Access Compliance Report

Public Rights-of-Way

Intersection ID: 15599	Main Street: COLVILLE_RD	Cross Street: EASTOVER_RD	Location: SW
ADA ID: 14A191A8EB6F	Ramp Type: PerpDiag	Initial Pass/Fail: Fail	Overall Compliance: No
		Severity Score: 1.25

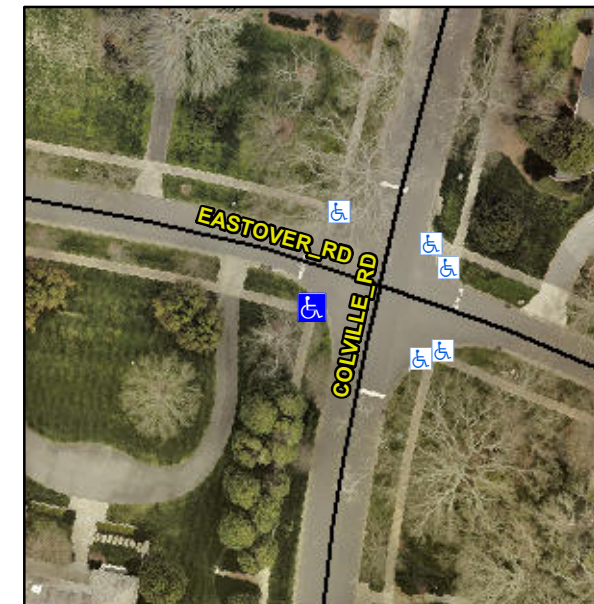
Not Found, R304.5.3

Compliance	Description	Data	Compliance	Description	Data
N/A	Ramp Length (in)	60.0	Yes	Ramp Slope (%)	7.0
Yes	Ramp Width (in)	48.0	No	Ramp XSlope (%)	2.9
N/A	Flare Type LT	N/A	N/A	Flare Type RT	N/A
N/A	Flare Slope LT (%)	N/A	N/A	Flare Slope RT (%)	N/A
N/A	Flare Traversable LT?	N/A	N/A	Flare Traversable RT?	N/A
N/A	Landing Length (in)	N/A	N/A	DWS Provided?	N/A
N/A	Landing Width (in)	N/A	N/A	DWS Contrast?	N/A
N/A	Landing Slope (%)	N/A	N/A	DWS Length (in)	N/A
N/A	Landing X Slope (%)	N/A	N/A	DWS Full Width?	N/A
N/A	Landing Curb? (Y/N)	N/A	N/A	DWS Offset (in)	N/A
N/A	Shared Landing?	N/A			
N/A	Gutter Ponding?	N/A	N/A	Gutter Slope (%)	N/A
N/A	Gutter Lip Ht (in)	N/A	N/A	Gutter X Slope (%)	N/A
N/A	Painted X Walk1?	No	N/A	Painted X Walk2?	No
	X Walk 1 Direction	To SE		X Walk 2 Direction	To NE
N/A	X Walk 1 Width (in)	N/A	N/A	X Walk 2 Width (in)	N/A
	X Walk 1 Slope (%)	3.0		X Walk 2 Slope (%)	0.3
	X Walk 1 X Slope (%)	0.0		X Walk 2 X Slope (%)	1.6

Remove & Replace Curb Ramp With Two New Directional Ramps or Equivalent.
